Datum: 21 juni 1989

DMA-LOCKUP NA RESETTEN VAN COMPUTER

Technical Advice Notice

MODEL/ ASSEMBLY: ST & MEGA COMPUTERS

Zie bijgaand schema.

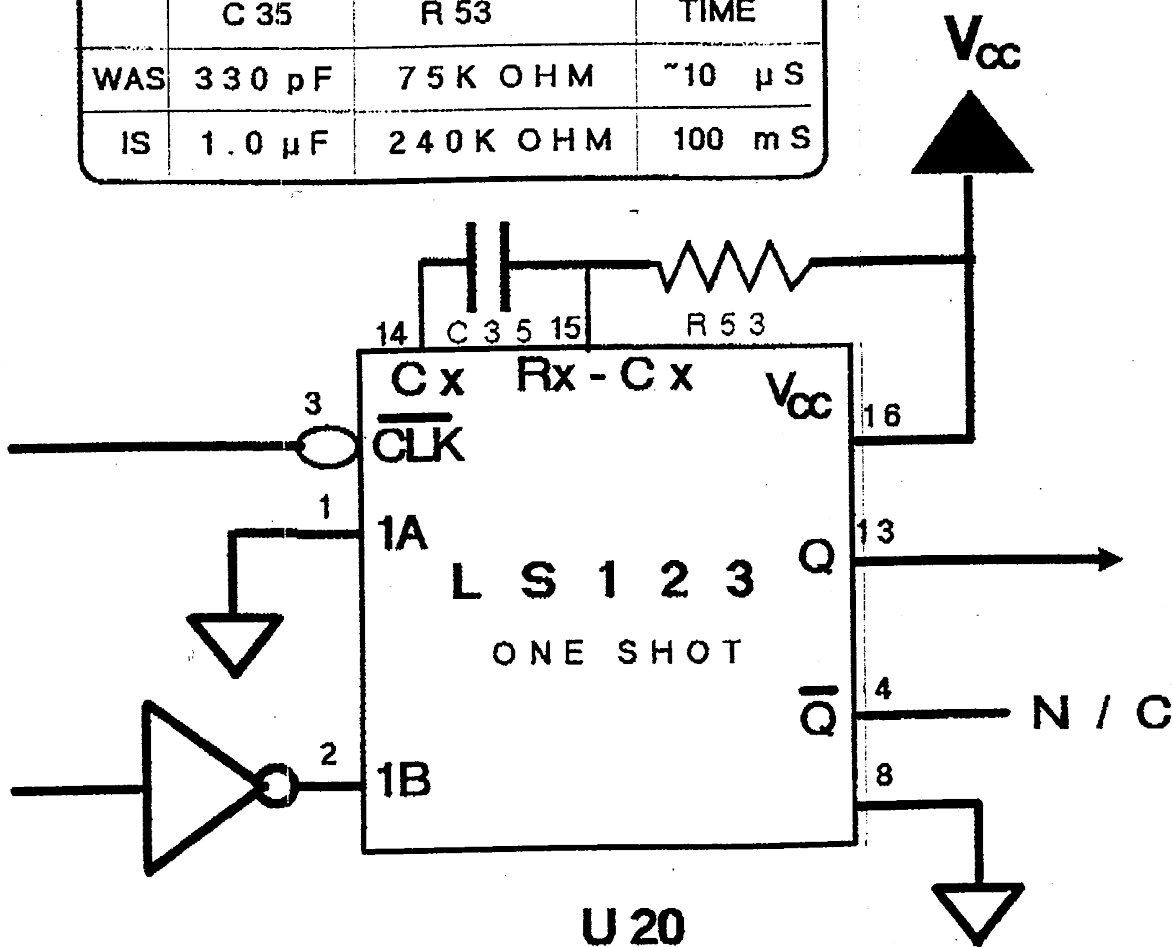
Bij sommige oudere harddisks (SH205/megafile 20) komt het voor dat de harddisk na reset niet meer aanspreekbaar is. De enige manier om toch weer met de harddisk aan de slag te kunnen is het compleet aan/uit schakelen van het gehele systeem.

Dit probleem wordt veroorzaakt doordat er binnen 25uS na het eerste RESET signaal weer een RESET signaal op de bus aanwezig is. Sommige harddisks zijn hier gevoelig voor. Het probleem is sterk afhankelijk van de gebruikte harddisk en computer (combinatie). De oplossing is de tijd van de schakeling V20 (74LS13, one shot) te verlengen van 10uS tot \pm 100uS. Dit verlengen van de tijd kunt u bereiken door de volgende handelingen:

Vervang R53 van 75Kohm door 240 Kohm, 1/4W, \pm 5%, Carbon
Vervang C35 van 330pF door 1.0 uF, > 25VDC, \pm 20%, Ceramisch.

COMPONENT VALUES			
	C 35	R 53	one shot TIME
WAS	330 pF	75K OHM	~10 μ S
IS	1.0 μ F	240K OHM	100 mS

FOR MODELS: SH205/MEGAFILE20 ONLY.

NOTE: Due to the differences in Buffering and Gating of the $\bar{1}$ -RESET signal, these changes are NOT required on the MEGAFILE30 or MEGAFILE60. Although NOT required, these values MAY provide some additional noise immunity. The reference designators will be different for these models.
